Access Compliance Report

Public Rights-of-Way

Intersection ID: 47651	Main Street: MULLAN_LN	Cross Street: MORAY_CT	Location: SE
ADA ID: B7EB9D6D259E	Ramp Type: Perp	Initial Pass/Fail: Pass	Overall Compliance: No
		Severity Score: 0.25

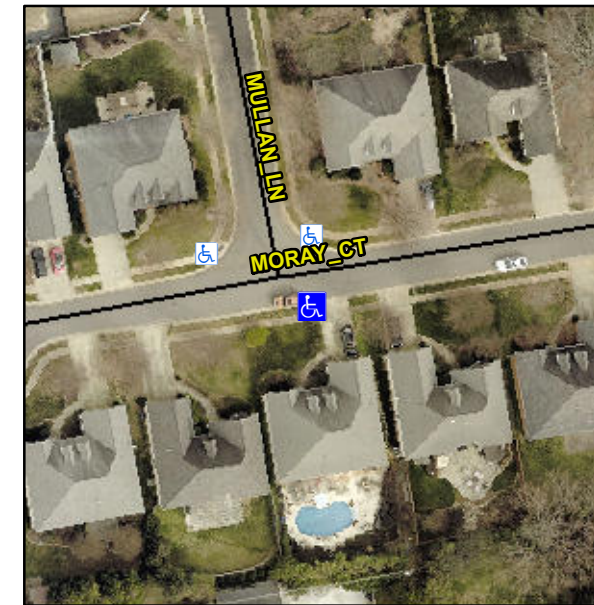
**Not Found, R304.5.3, R304.2.2-Perp,
R304.3.2-Para**

Compliance	Description	Data	Compliance	Description	Data
N/A	Ramp Length (in)	47.5	Yes	Ramp Slope (%)	5.7
Yes	Ramp Width (in)	48.0	No	Ramp XSlope (%)	2.7
N/A	Flare Type LT	Sloped	N/A	Flare Type RT	N/A
N/A	Flare Slope LT (%)	9.1	Yes	Flare Slope RT (%)	3.1
N/A	Flare Traversable LT?	Yes	N/A	Flare Traversable RT?	Yes
Yes	Landing Length (in)	48.0	Yes	DWS Provided?	Yes
Yes	Landing Width (in)	48.0	Yes	DWS Contrast?	Yes
No	Landing Slope (%)	3.2	Yes	DWS Length (in)	24.5
No	Landing X Slope (%)	3.3	Yes	DWS Full Width?	Yes
N/A	Landing Curb? (Y/N)	No	Yes	DWS Offset (in)	0.0
N/A	Shared Landing?	No			
Yes	Gutter Ponding?	No	Yes	Gutter Slope (%)	0.5
Yes	Gutter Lip Ht (in)	0.0	No	Gutter X Slope (%)	2.7
N/A	Painted X Walk1?	No	N/A	Painted X Walk2?	N/A
	X Walk 1 Direction	To N		X Walk 2 Direction	N/A
N/A	X Walk 1 Width (in)	N/A	N/A	X Walk 2 Width (in)	N/A
	X Walk 1 Slope (%)	2.1		X Walk 2 Slope (%)	N/A
	X Walk 1 X Slope (%)	2.5		X Walk 2 X Slope (%)	N/A

**Remove & Replace Entire Ramp.
Remove & Replace Gutter.**
